# CITY OF MUSKEGON

## HISTORIC DISTRICT COMMISSION

**November 4, 2025 @ 4:00 PM**

390 W. MUSKEGON

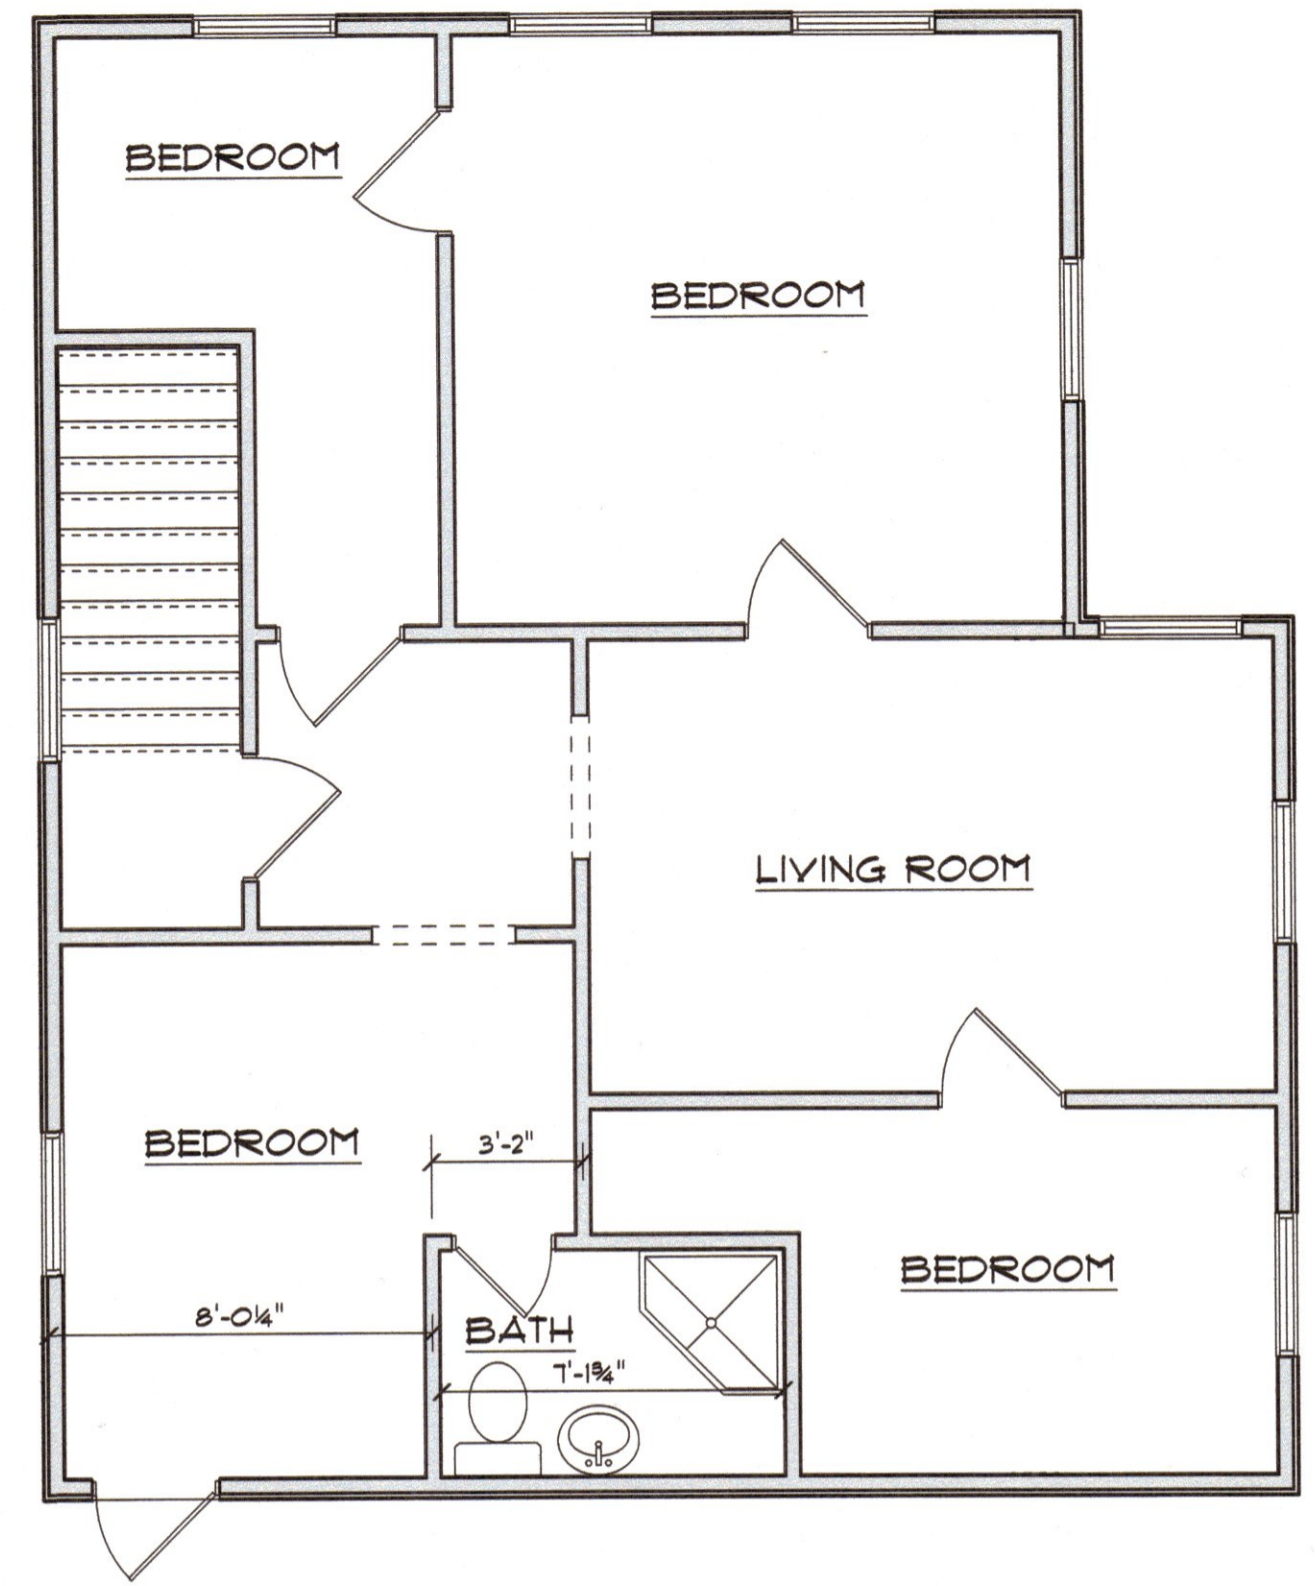
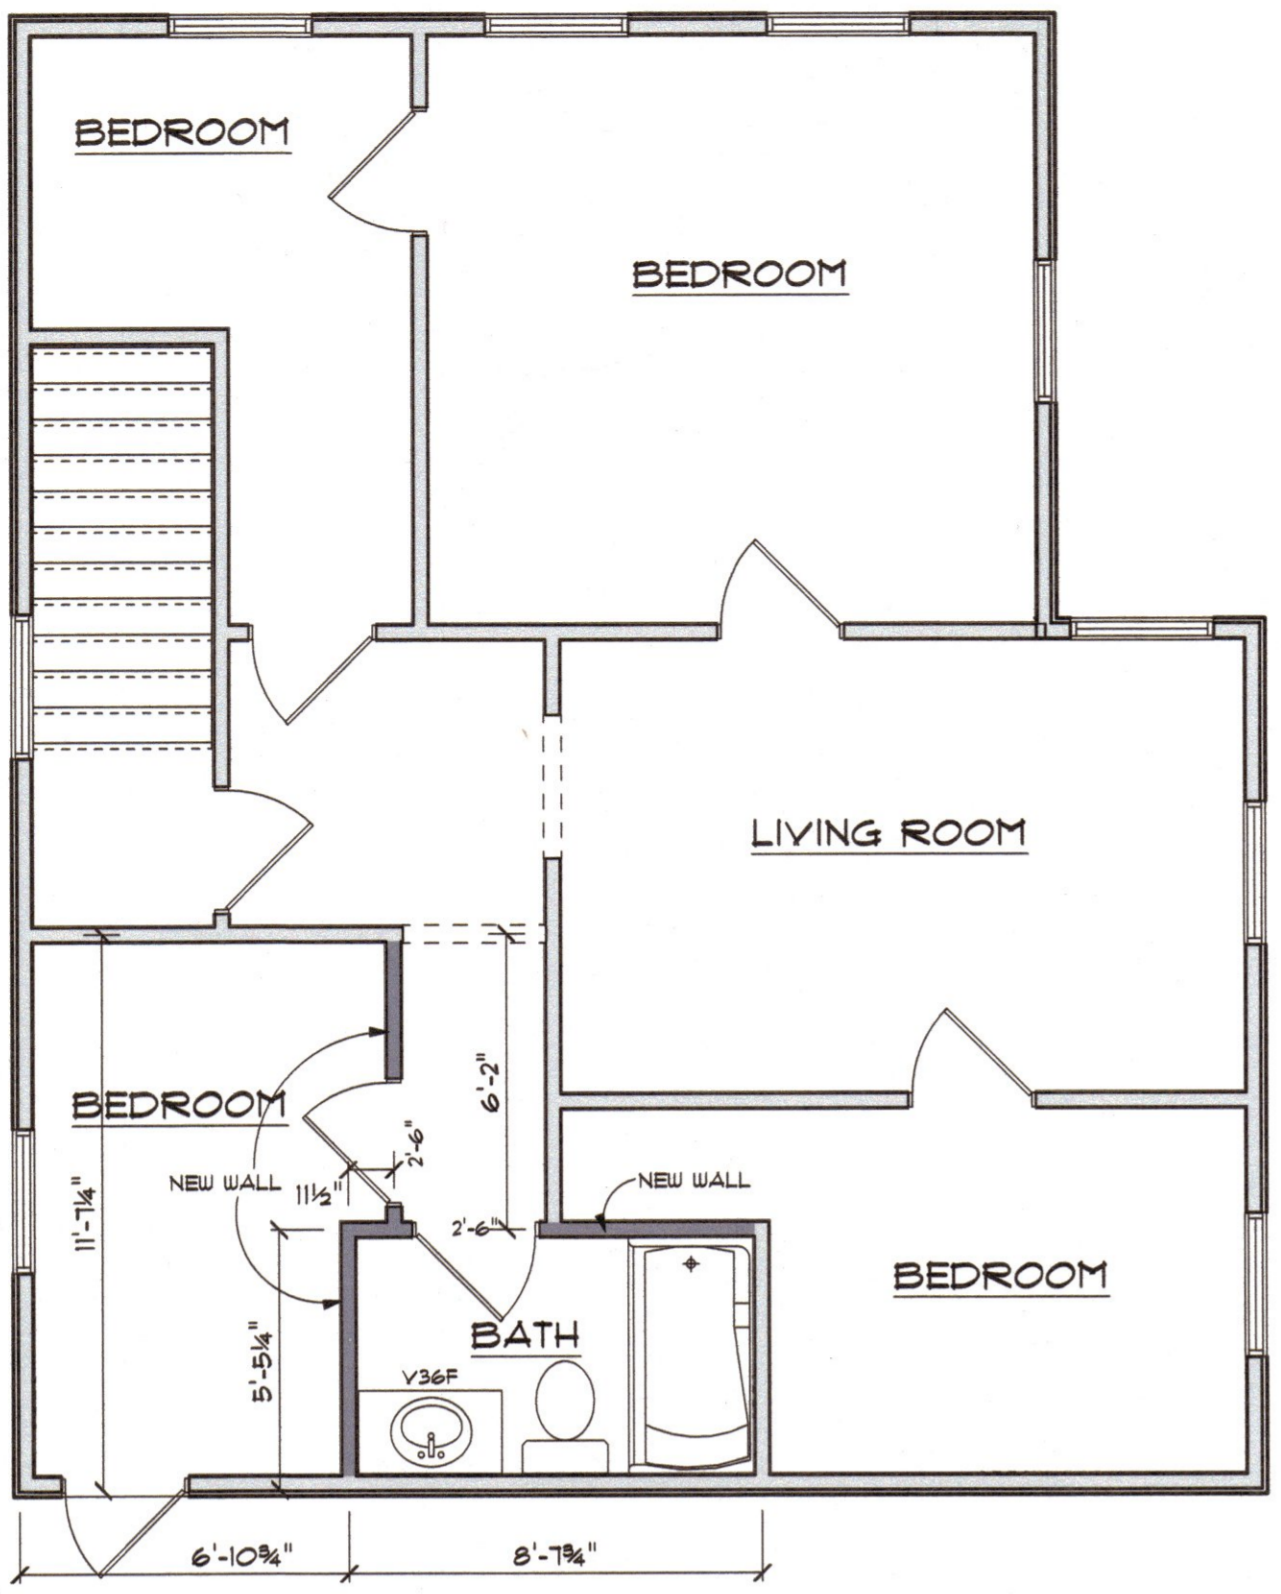
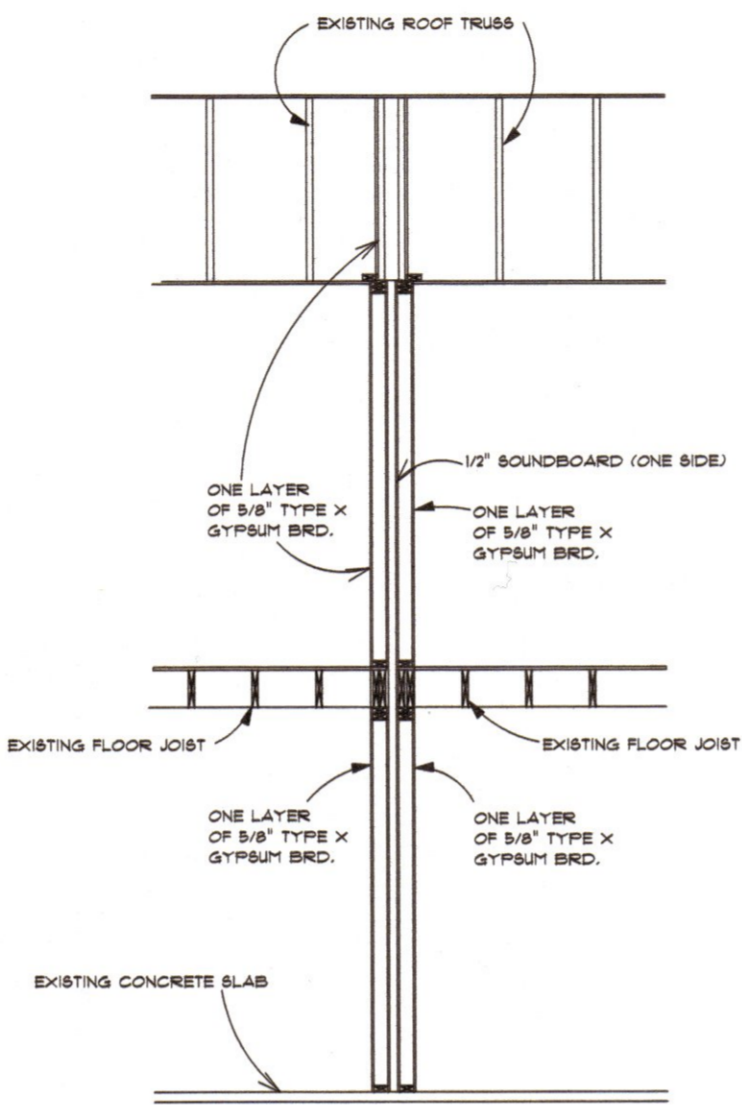
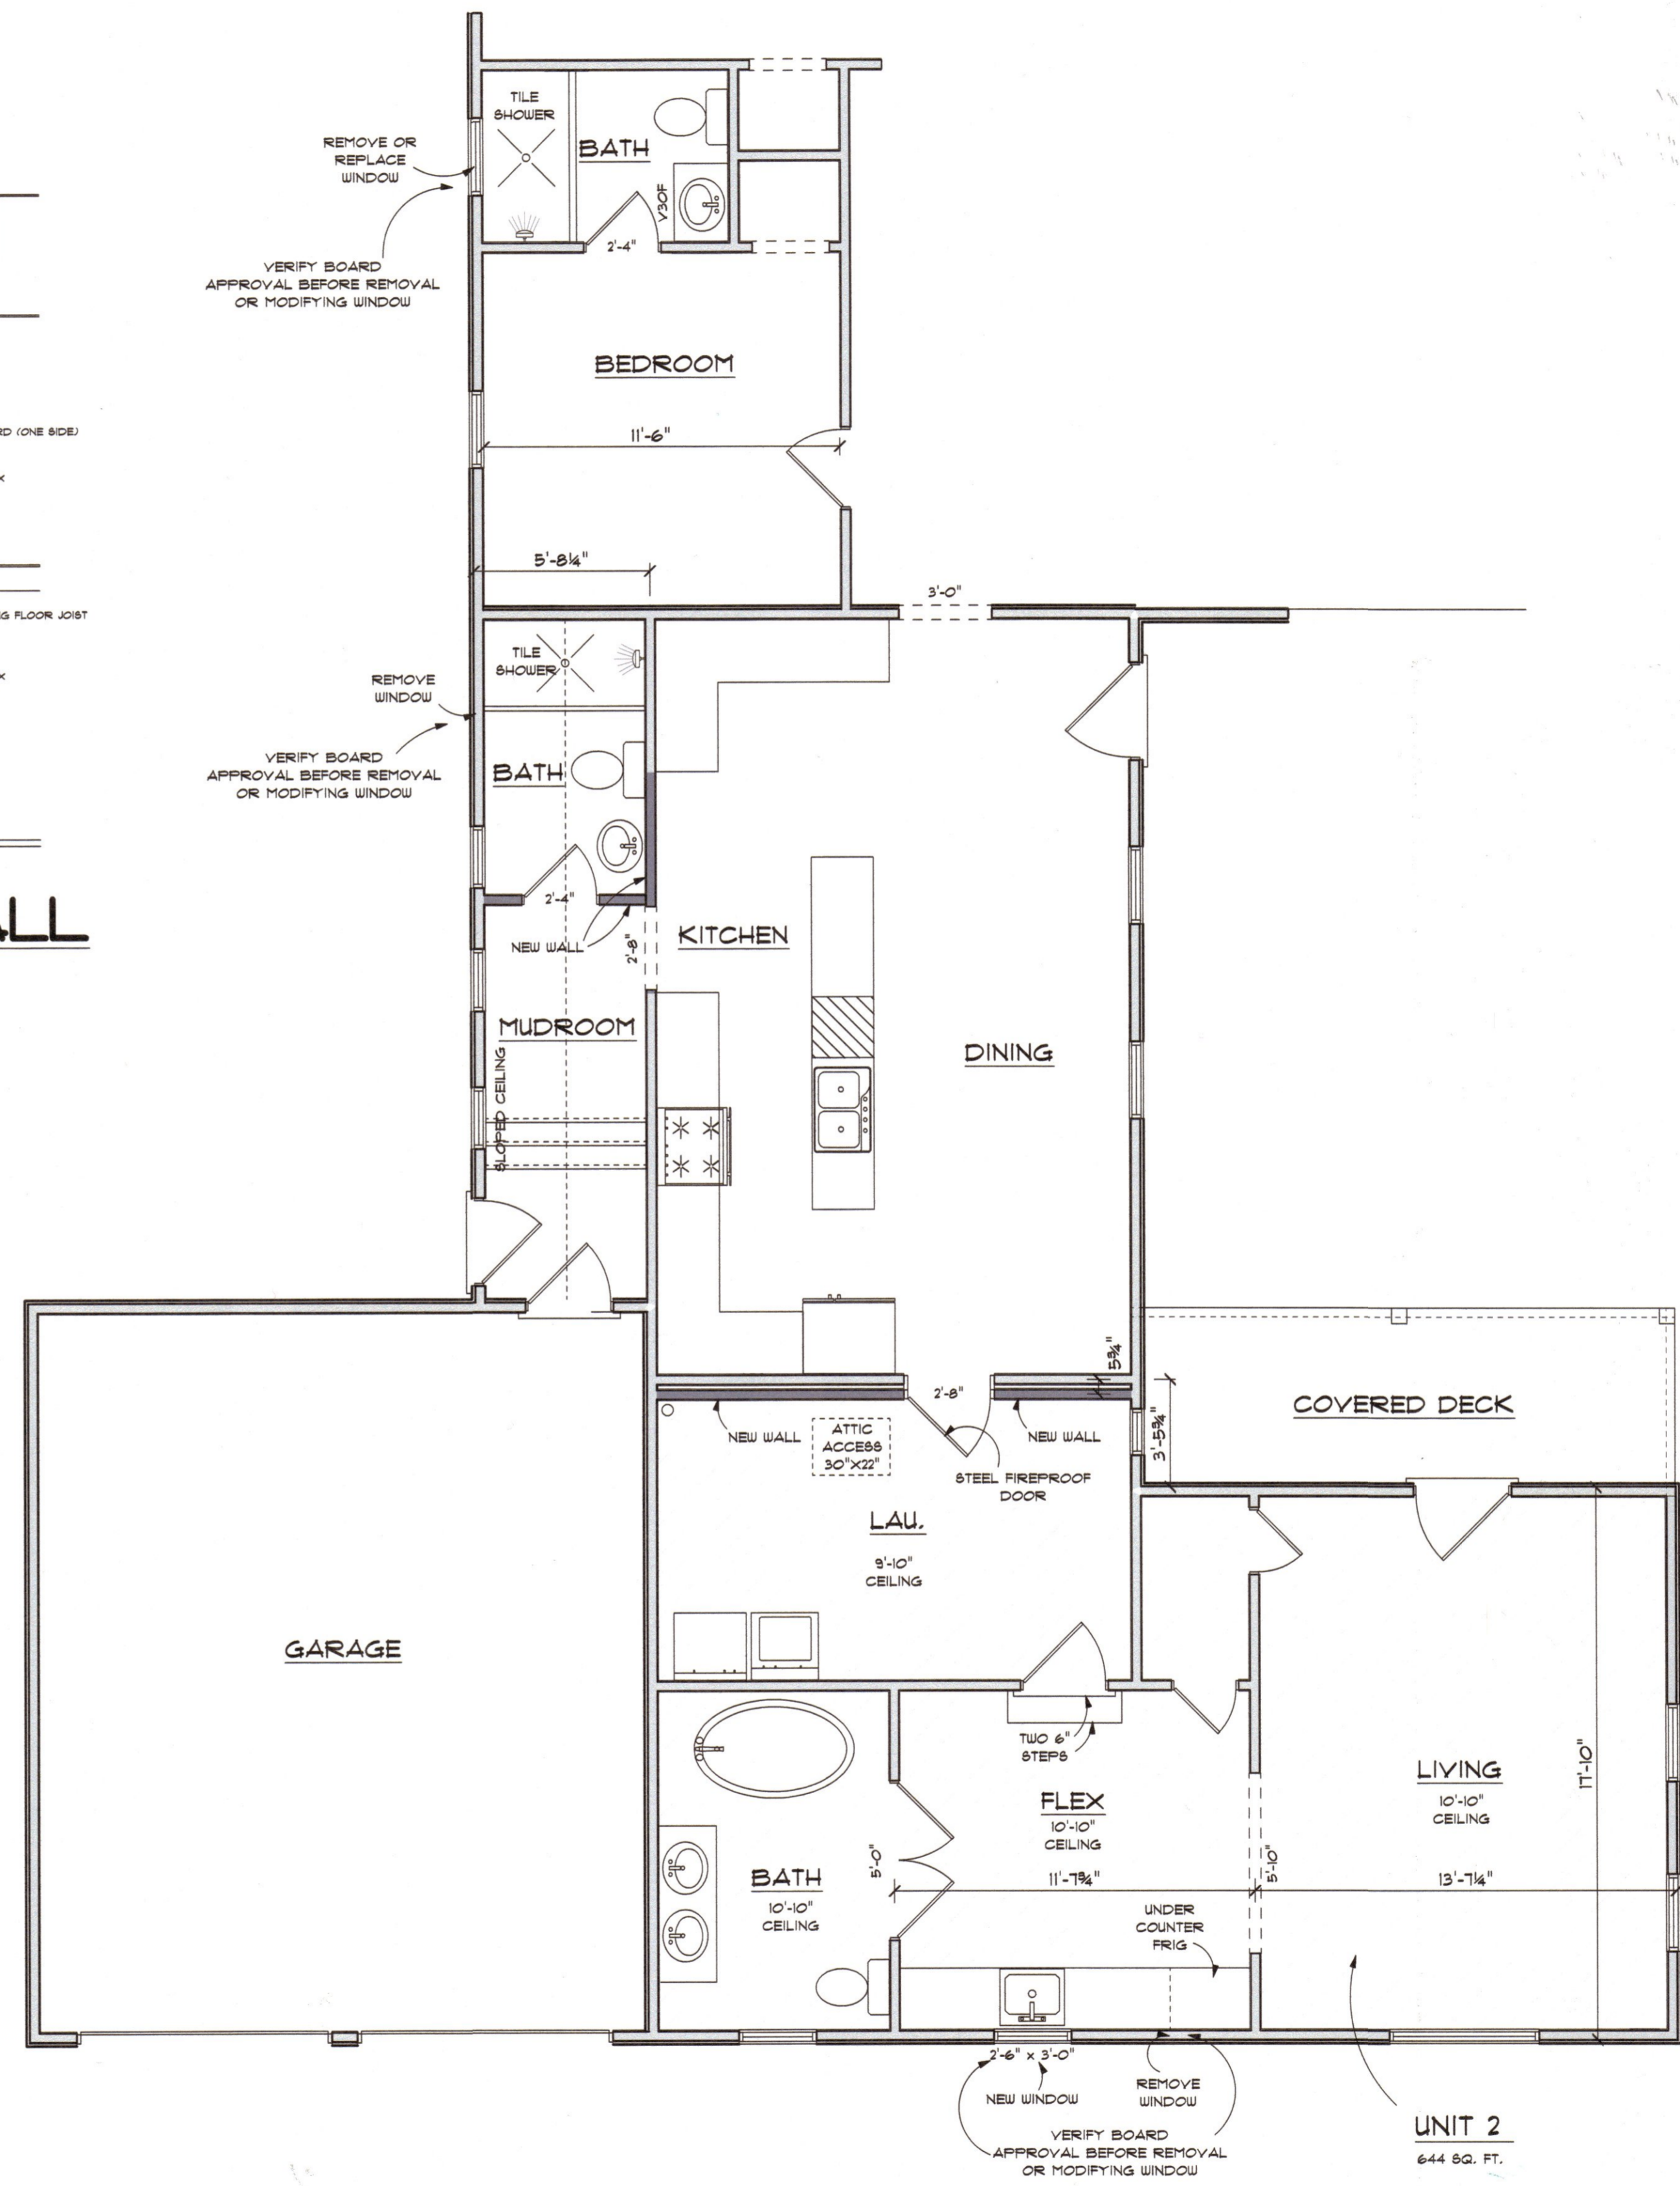
<b>Case 2025-30: 390 W. Muskegon</b>	<b>Description of Work:</b> Windows and Gutters
<b>Applicant:</b> Lusk Properties	<b>District:</b> Houston
<b>Current Use:</b> Residential	<b>Date of Construction:</b> 1/1/1890
<p><b>Discussion:</b></p> <p>The applicant is seeking approval to replace the windows in the house (excluding the garage windows) with single-hung vinyl windows of the same size and appearance including a vertical mullion within each pane, remove two windows on the east (side) elevation and two windows on the north (rear) elevation and side over the existing openings to match the rest of the house, install a smaller, 30"x36" vinyl replacement window within an existing window opening on the north elevation and side over the remaining lower portion of the rough opening to match the rest of the house, and install gutters on the eaves on portions of the east and north elevations.</p>	
<p><b>Standards:</b></p> <p>See attached <i>Window, Door, and Exterior Woodwork Standards and Guidelines</i> in Case 2025-29, above.</p>

<p><b>Deliberation:</b></p> <p>I move that the HDC (approve/deny) the request to replace the windows in the house (excluding the garage windows) with single-hung vinyl windows of the same size and appearance including a vertical mullion within each pane, remove two windows on the east (side) elevation and two windows on the north (rear) elevation as identified in the November 4, 2025 HDC Staff Report and side over the existing openings to match the rest of the house, install a smaller, 30"x36" vinyl replacement window within an existing window opening on the north elevation as identified in the November 4, 2025 HDC Staff Report and side over the remaining lower portion of the rough opening to match the rest of the house, and install gutters on the eaves on portions of the east and north elevation as long as the work meets all zoning requirements and the necessary permits are obtained.</p>
